Water & Wastewater Planning Review

Weinam Creek Priority Development Area

PREPARED FOR REDLAND INVESTMENT CORPORATION

ISSUE	DATE	ISSUE DETAILS	AUTHOR	CHECKED	APPROVED
A	07.04.2020	Final	T. Chalmers	D. Collins	T. Chalmers

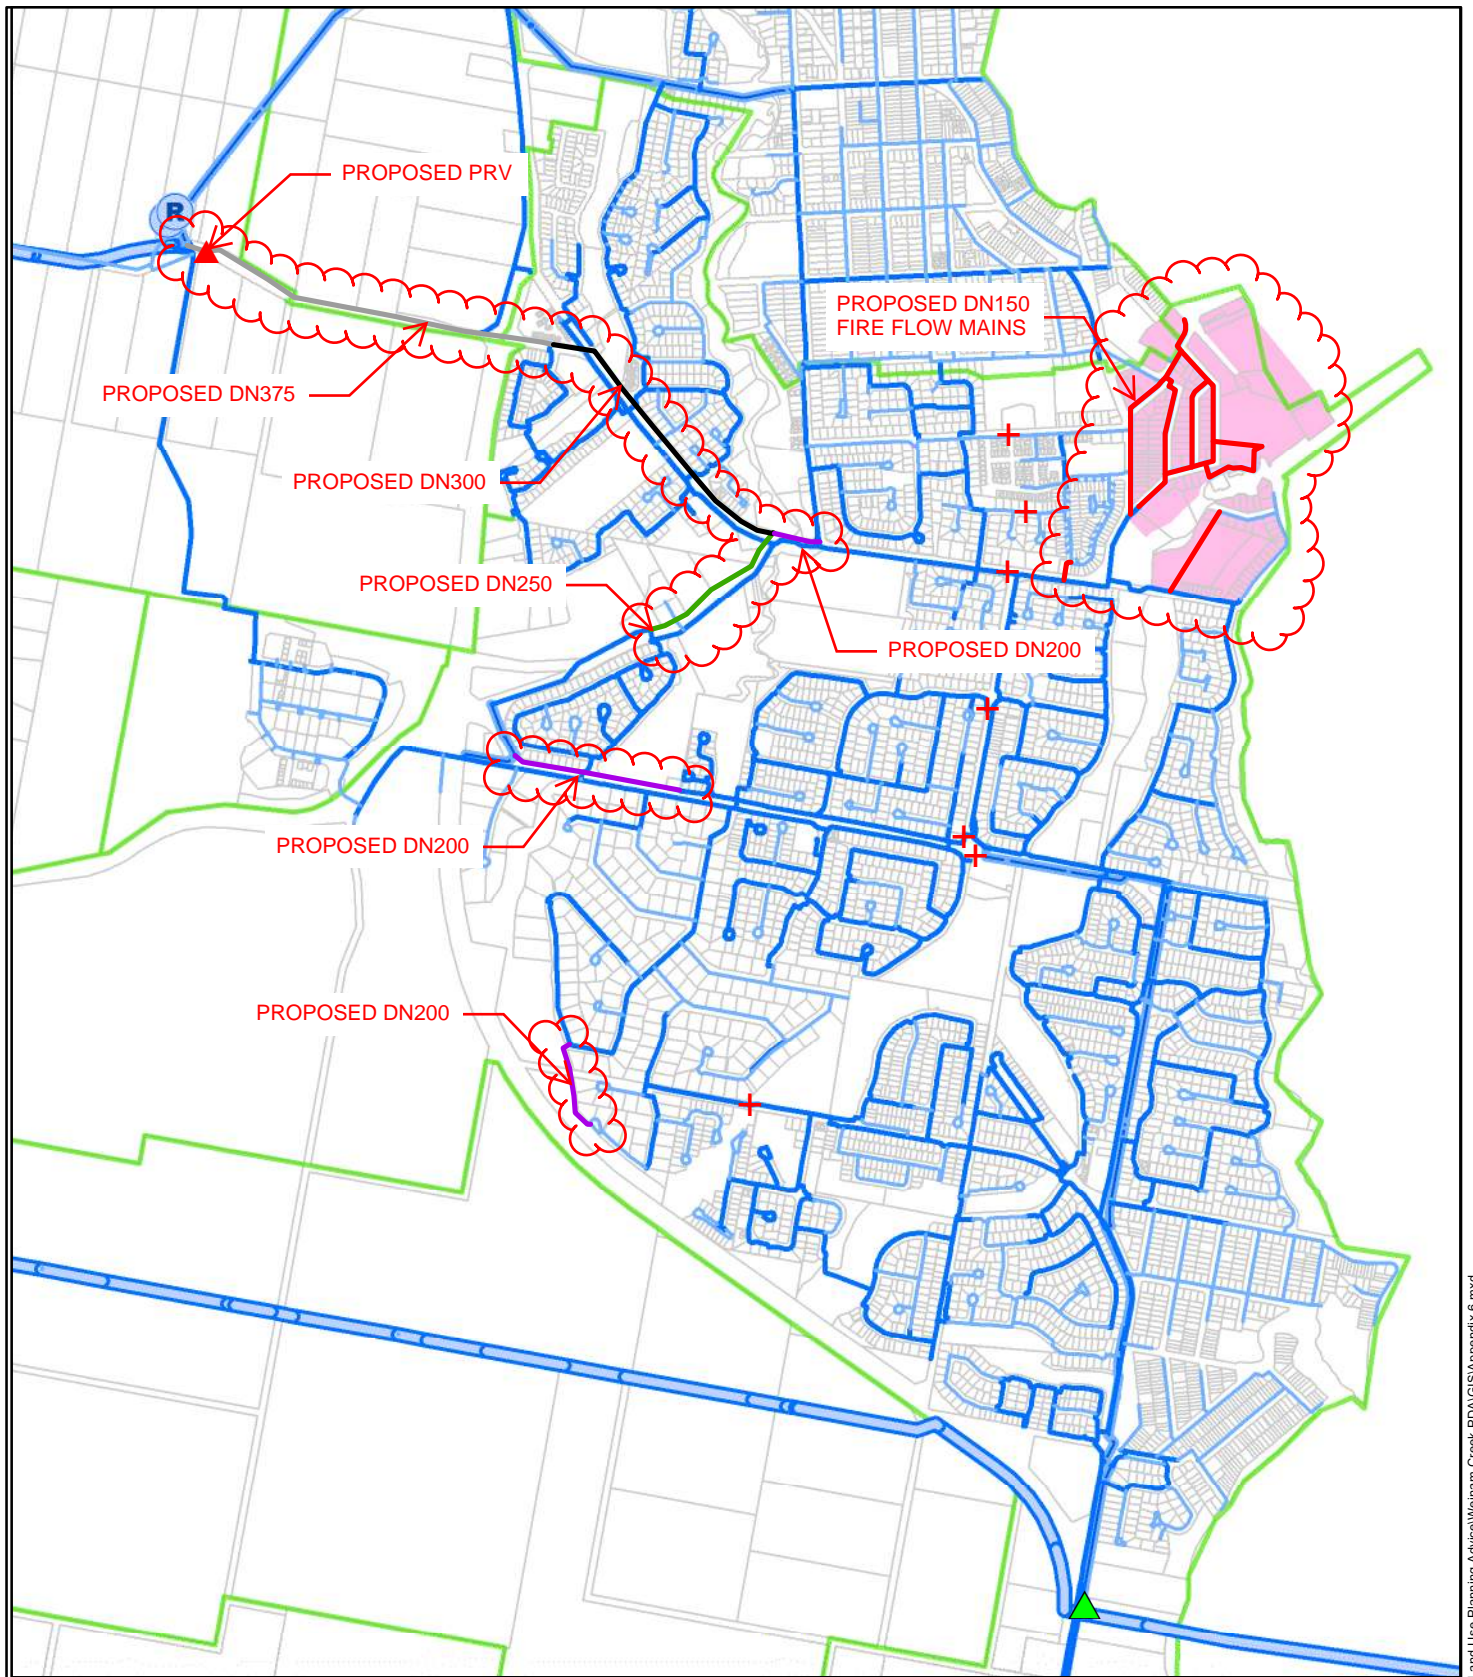
Both options are included within Appendix B, with Option 2 the preferred servicing strategy. On the basis that Option 2 is the preferred strategy, Option 1 will not be discussed any further within this report.

Item	RCC Proposed Augmentation	Trigger	Calibre Comments
1	1,135m of DN375 Water Main	PDA Maximum Day Demands	Agreed, critical connection to trunk main required to achieve minimum pressure requirements. Existing network is undersized to cater for PDA demands. Note, 260m of DN150 augmentations triggered by Maximum Day Demands are in addition to Fire Flow augmentations below.
2	830m of DN300 Water Main		
3	420m of DN250 Water Main		
4	640m of DN200 Water Main		
5	260m of DN150 Water Main		
6	PRV / Meter Assembly	PDA Fire Flows	Agreed, new PRV and boundary to configuration required for new connection to DN600 trunk main on Giles Road. Reticulation augmentations are reasonable considering fire flows have increased from 15 L/s to 30 L/s.
7	200m of DN200 Water Main		
8	1,250m of DN150 Water Main
